CITY OF MILWAUKIE

PLANNING COMMISSION

- 5.1 Summary: Harmony Park Apartments **(sent 9/20/18)**
Applicant/Owner: Cascadia Planning + Development Services/HPA 2, LLC
Address: 6115 SE Harmony Rd
File: VR-2018-005, NR-2018-002, DEV-2018-006
Staff: Brett Kolver, Associate Planner

Figure 1: The corrected WQR approximated in red based on steep slopes adjacent to Minthorn Creek

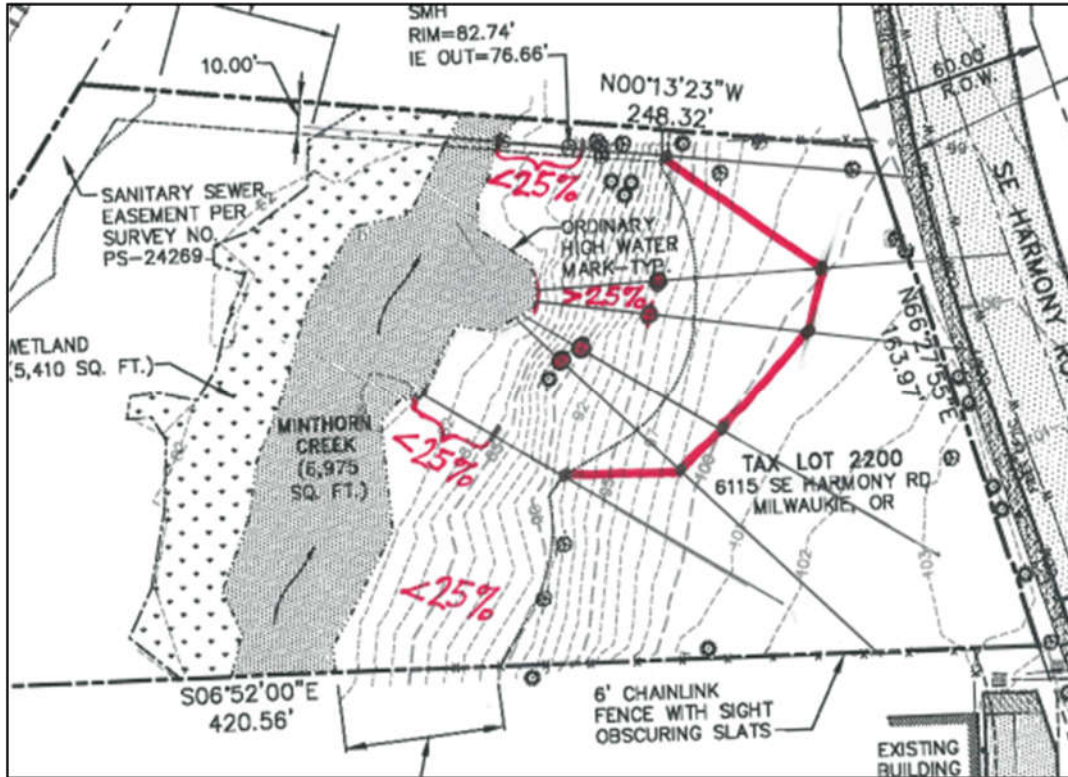
The delineated wetland and Minthorn Creek appear to be accurately mapped. No wetlands were observed on the south side of the stream during ESA’s August 27, 2018 site visit.

Figure 2: Purpose of proposed tree removal highlighted in yellow is unclear.

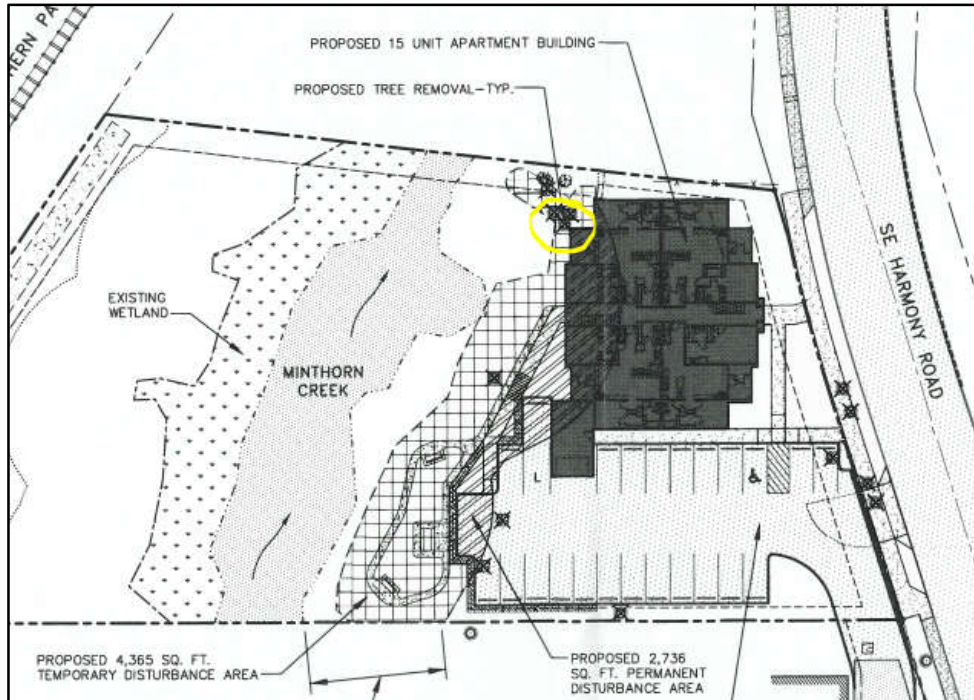
Response: It’s not clear why the three trees circled in yellow in Figure 2 below require removal (too close to the proposed building?). No grading is proposed in that area according to Sheet C – 2. Otherwise the tree removal plan on Sheet 5 of 11 looks reasonable.
